Contract #: 04-0120F4Cty: SF/ALA Rte: 80 PM: 13.2/13.9File #: 69.25B**QUALITY ASSURANCE -- NON-CONFORMANCE REPORT****Location:** Changxing Island, Shanghai, P.R. China**Report No:** NCR-000740**Prime Contractor:** American Bridge/Fluor Enterprises, a JV**Date:** 23-May-2010**Submitting Contractor:** Zhenhua Port Machinery Company, Ltd (ZPMC), Changxing Island**NCR #:** ZPMC-0703**Type of problem:**

Reference Description: Unknown Material being tacked onto a CB10 Side Panel not conforming to the AWS D1.5 Section 12 Requirement

Dear: Mr. Charles Kanapicki
Job Name: SAS Superstructure

Subject: NCR No. ZPMC-0703

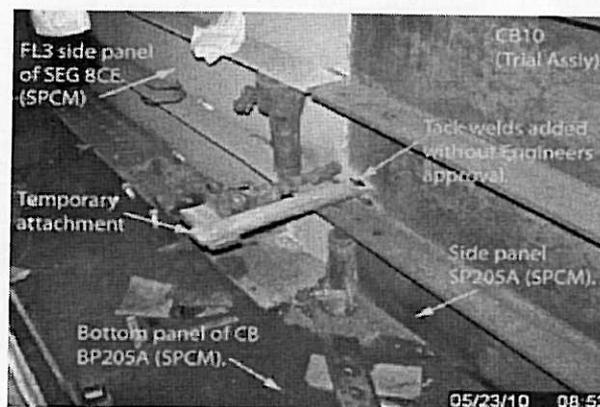
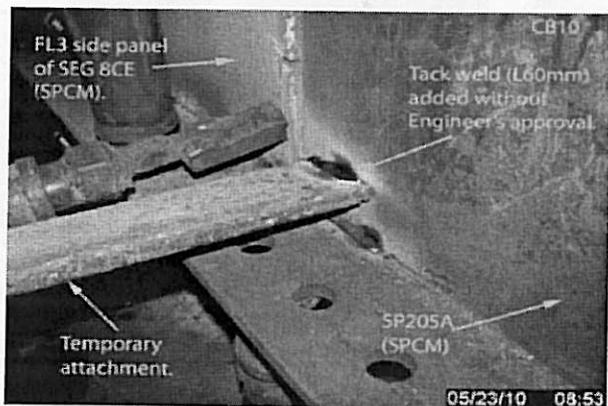
During Quality Assurance (QA) random in-process observations of the fabrication of Cross Beam CB10, this QA inspector discovered the following issue:

- During fit-up of Cross Beam CB10 side panel to FL3 panel of OBG segment 8CE, ZPMC personnel had temporarily tack welded a steel plate at the south end of side panel (SP205A) of CB10.
- Side Panel – SP205A is identified on the approved shop drawings as Seismic Performance Critical Member (SPCM).
- The size and length of the tack weld do not meet the requirements of AWS D1.5 2002, Table 12.2.
- The approved Shop drawing does not specify any weld in this area.
- No fabrication procedure was available with QC.
- The material composition of the temporary steel plate is not known.
- Cross Beam 10 is located in the Trial Assembly.
